Item Name: Crosstube Turning Detail

<b>DART AEROSPACE LTD</b>		<b>Work Order:</b> 112785
<b>Description:</b> Crosstube Assembly		<b>Part Number:</b> D407-667-145
<b>Inspection Dwg:</b> D407-667-145 Rev: C		<b>Page 1 of 2</b>

DART AEROSPACE LTD HAWKESBURY, ONTARIO, CANADA	
DRAWING NO. D407-667-145	REV. C SHEET 1 OF 4
TITLE CROSSTUBE ASSY (407 HIGH FWD)	SCALE NTS
COPYRIGHT © 2002 BY DART AEROSPACE LTD THIS DOCUMENT IS PRIVATE AND CONFIDENTIAL AND IS SUPPLIED ON THE EXPRESS CONDITION THAT IT IS NOT TO BE USED FOR ANY PURPOSE OR COPIED OR COMMUNICATED TO ANY OTHER PERSON WITHOUT WRITTEN PERMISSION FROM DART AEROSPACE LTD.

DRAWING NO. D407-667-145	TITLE CROSSTUBE ASS'Y (407 HIGH FWD)	REV. C	<b>DART AEROSPACE LTD ENGINEERING ORDER</b>		D.E.O. NO. D407-667-145-C-1	SHEET NO. SHEET 1 OF 1	SCALE NTS
DRAWN <i>Q</i>	CHECKED <i>ASS</i>	MFG. APPR. <i>BS</i>	APPROVED <i>WD</i>		DE APPR. <i>##</i>		
DATE 11.07.15	DATE 11.07.22	DATE 11.07.22	DATE 11/07/22		DATE 11.07.21

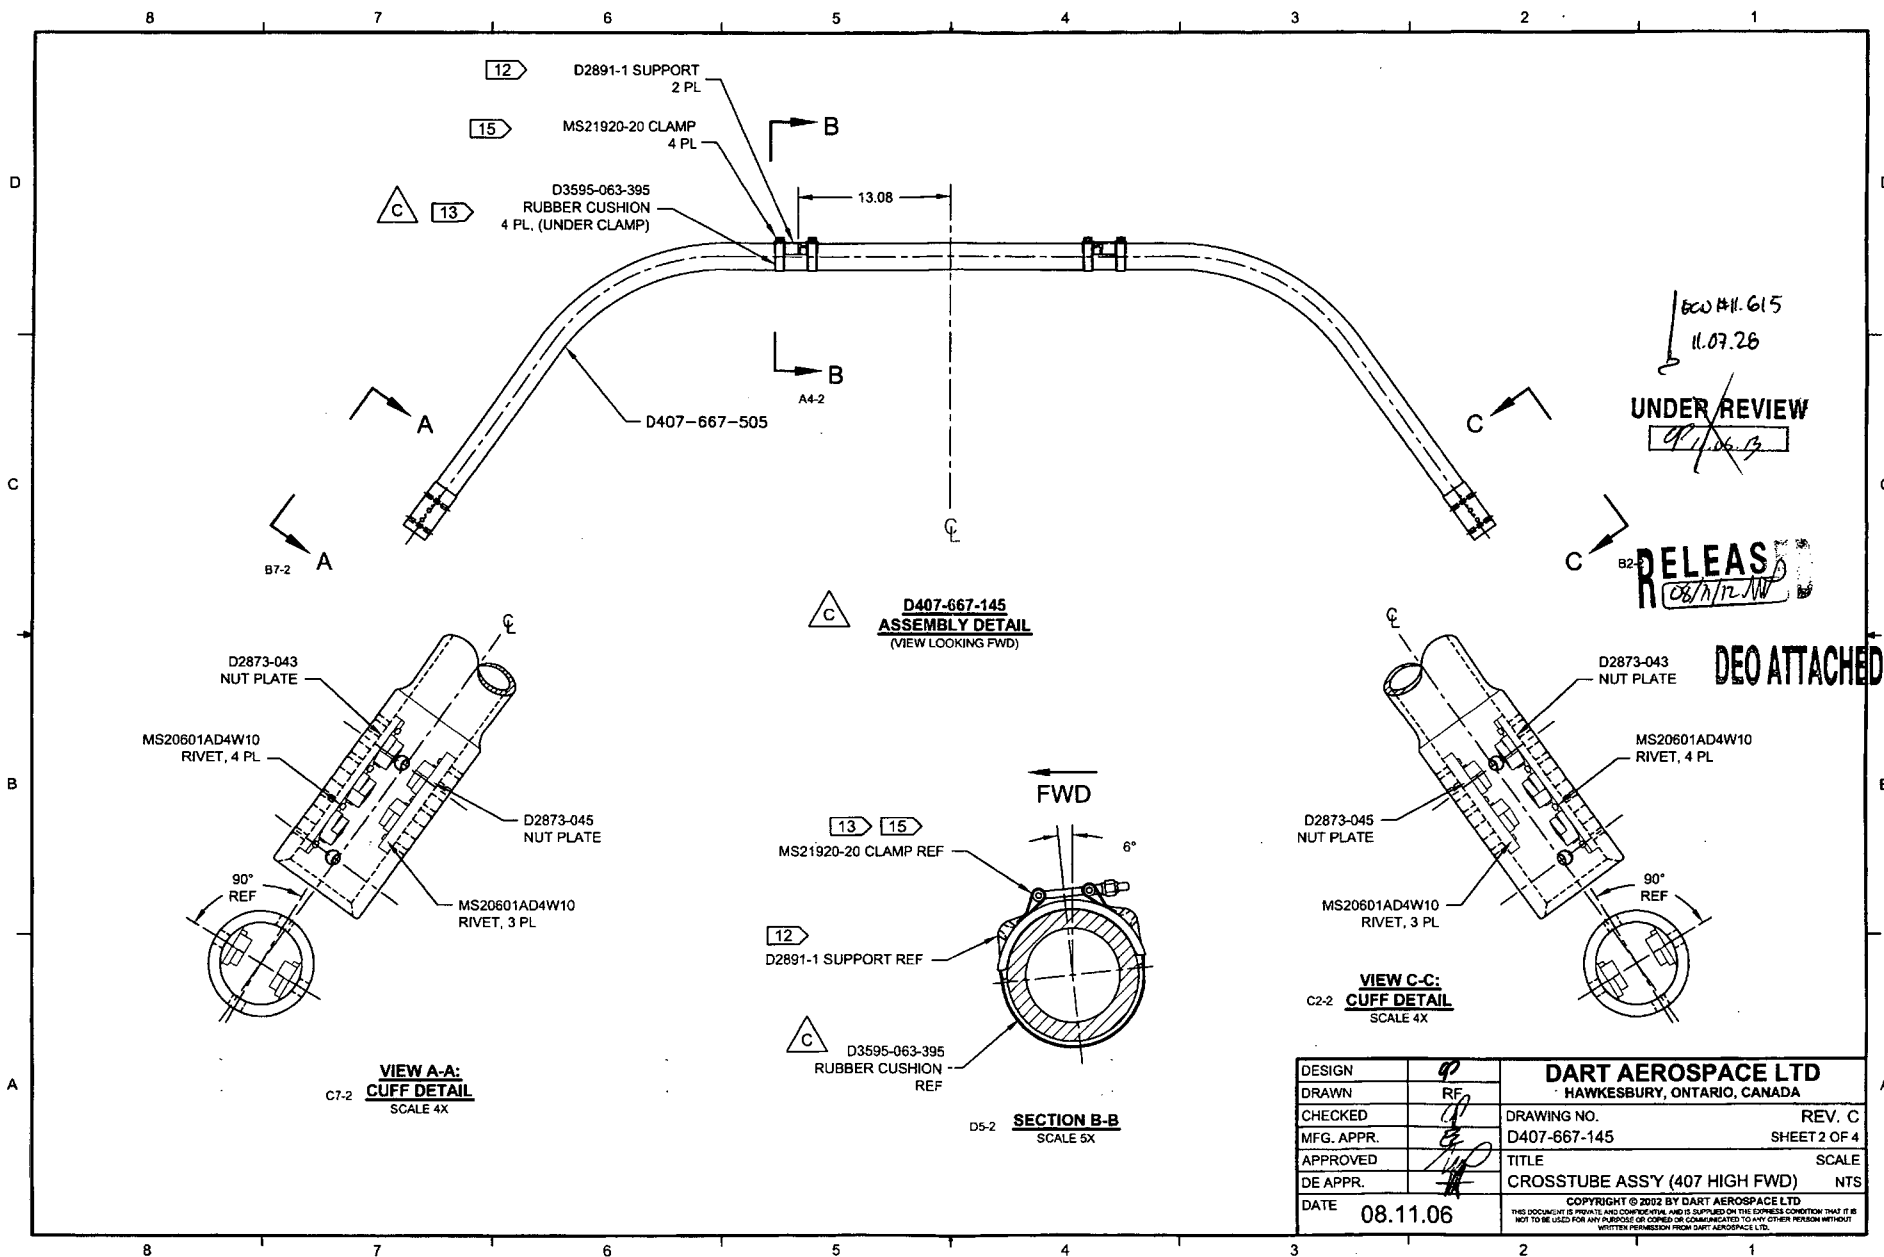
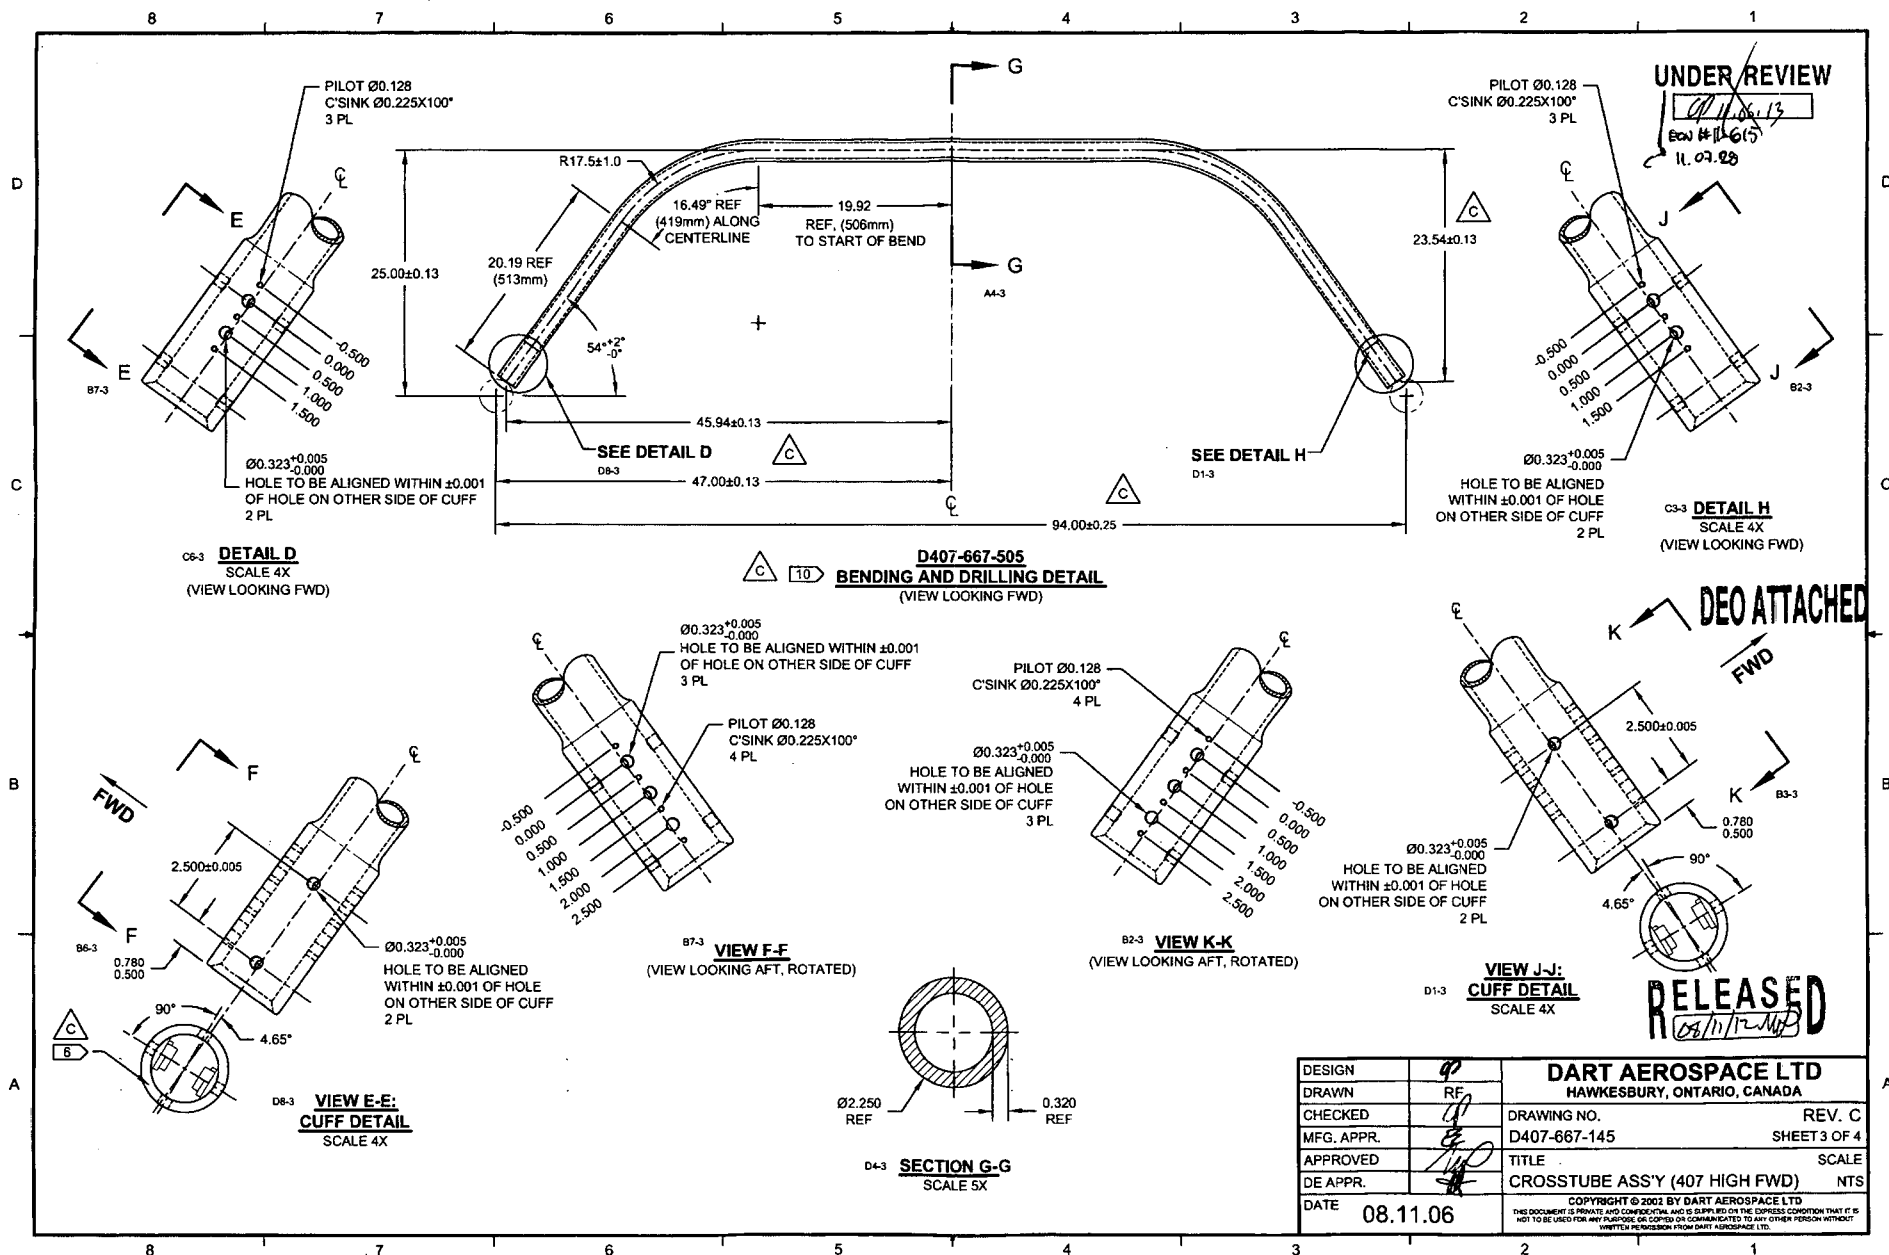
**PURPOSE:**

REPLACE MAGNOBOND WITH PROSEAL.

Item	Qty -145	Part Number	Description
9	A/R	PROSEAL 890 B-2	SEALANT, AMS-S-8802 CLASS B-2

9	A/R	MAGNOBOND 6398	ROCKWELL SPECIFICATION RBO-120-023 ADHESIVE (TEXTRON/BELL SPEC. 299-947-100, TYPE II, CLASS 2 ADHESIVE)
---	-----	----------------	---

NOTE 12 & 15, SHEET 1 IS AMENDED AS FOLLOWS:

- 12) TO INSTALL D2891-1 SUPPORT: ABRASE MATING SURFACE OF SUPPORT AND CROSSTUBE WITH 180-GRIT SANDPAPER AND REMOVE RESIDUE WITH MEK (OR EQUIVALENT). APPLY A 0.04" TO 0.07" THICK LAYER OF PROSEAL 890 CLASS B-2 (OR AMS-S-8802 CLASS B-2) SEALANT TO MATING SURFACE OF SUPPORT.
- 15) TORQUE CLAMPS 80 TO 100 IN-LB. ENSURE AT LEAST 1.5 THREADS SHOWING IN SAFETY AND THAT NUT HAS NOT BOTTOMED-OUT AFTER TORQUING. **PRIOR TO PACKAGING, RE-CHECK TORQUE ON CLAMPS AFTER PROSEAL 890 SEALANT HAS CURED FOR 72 HOURS.**

- 12) INSTALL D2891-1 SUPPORT USING 0.03" TO 0.06" THICK LAYER OF MAGNOBOND 6398 PER QSI 015. LET CURE FOR 12 HOURS AFTER INSTALLATION AND PRIOR TO PACKAGING.
- 15) TORQUE CLAMPS 80 TO 100 IN-LB. ENSURE AT LEAST 1.5 THREADS SHOWING IN SAFETY AND THAT NUT HAS NOT BOTTOMED-OUT AFTER TORQUING.

**DETAIL P**  
BONDING STRAP INSTALLATION 2 PL

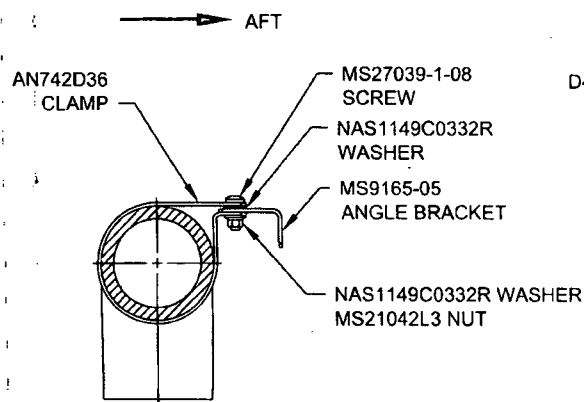
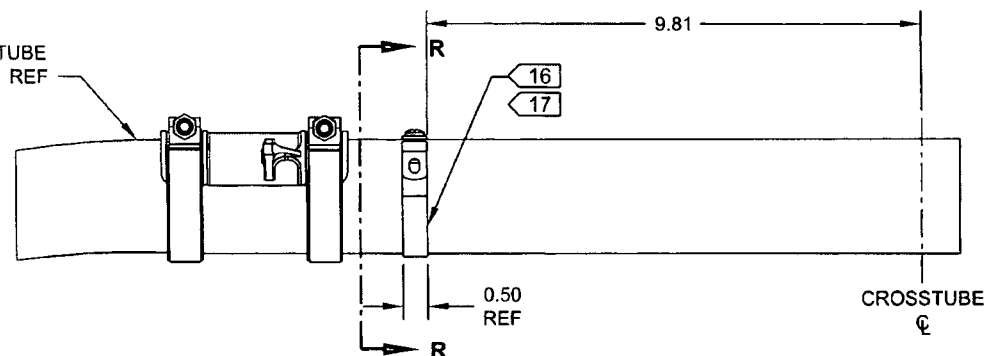
ADD ELECTRICAL GROUNDING STRAP

ITEM	QTY -145	PART NUMBER	DESCRIPTION
1	X	D407-667-145	CROSSTUBE ASSEMBLY (407 HIGH FWD)
⚡			
10	2	AN742D36	CLAMP
11	2	MS9165-05	ANGLE BRACKET
12	2	MS21042L3	NUT (OR MS21042-3)
13	2	MS27039-1-08	SCREW
14	4	NAS1149C0332R	WASHER (OR AN960C10L)

- 16) MASK AREA UNDER CLAMP PRIOR TO PAINTING
- 17) SEAL EDGES WHERE AN742D36 CLAMP MEETS WITH THE CROSSTUBE USING SIKAFLEX-241/-291 OR MIL-S-8802 CLASS B2 OR PROSEAL 890 SEALANT
- 18) PERFORM RESISTANCE CHECK TO ENSURE MAX RESISTANCE IS 10 MILLIOHMS
